Modifikation von Mikroprozessorkarten

Modification of microprocessor boards

For the processor card 1.811.774.12 used in the A812 recorder, modification kit 20.050.812.00 is required.

P.C. boards with layout 1.811.774.12 (see illustration)

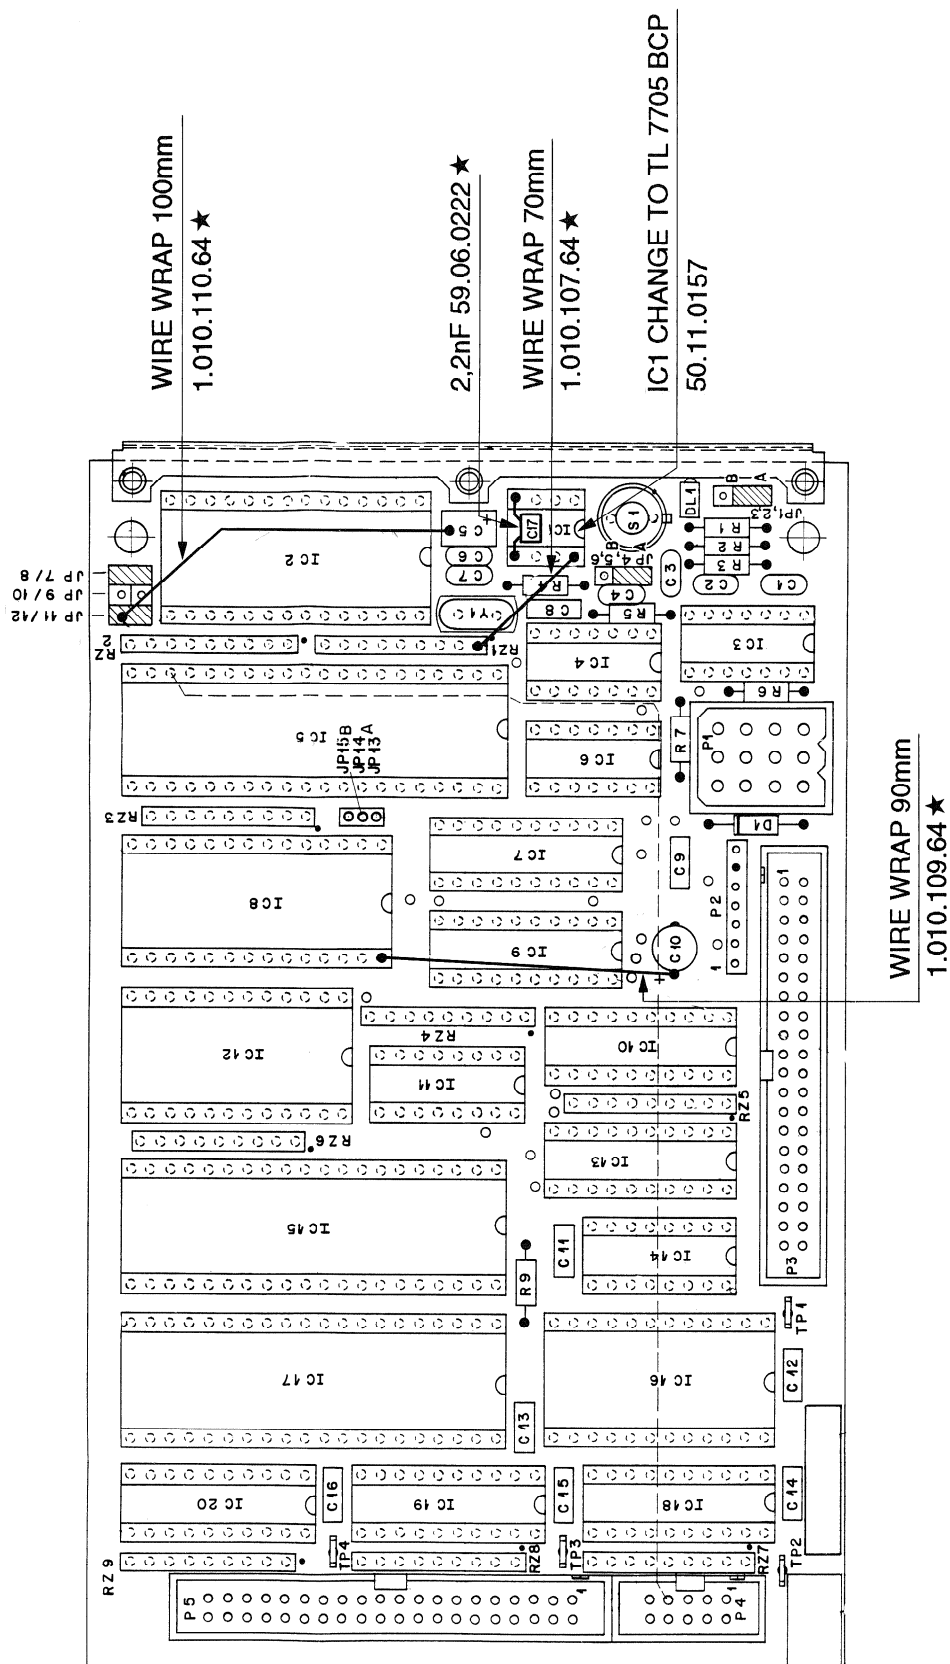
Diese Modifikation behebt das Problem "Error, Data lost", entstanden durch zeitweise fehlerhaften Reset des Mikroprozessors beim Einschalten der Maschine. Sie soll dringend bei batteriegepufferten Karten durchgeführt werden.

- IC 1, TL 7705 ACP entfernen, dafür neu TL 7705 BCP einsetzen.
- C 2,2nF zwischen PIN 4 und 5 von IC 14 einlöten.
- Wire-Wrap Draht l=100 von C5 (negativ) auf JS 12 (Masse).
- Wire-Wrap Draht l=70 von IC 1, PIN 8 auf PIN 1 von R21.
- Wire-Wrap Draht l=90 von C10 (positiv) auf PIN 28 von IC 8.
- Neues, um 1 erhöhtes Indexschild auf dem Beschriftungsstreifen anbringen.

This modification solves the problem "Error, Data lost", caused by occasional incorrect microprocessor reset during the "power on" routine. The alterations listed below are of prime importance with battery buffered cards.

- Replace IC 1, TL 7705 ACP with TL 7705 BCP
- Fit C 2,2nF capacitor between pin 4 and 5 of IC14
- Fit wrap-wire l=100 from C5 (negative) to JS 12 (shield)
- Fit wrap-wire l=70 from IC 1, pin 8 to pin 1 of R21
- Fit wrap-wire l=90 from C10 (positive) to pin 28 of IC 8
- Fit index label of next higher number to legend strip.
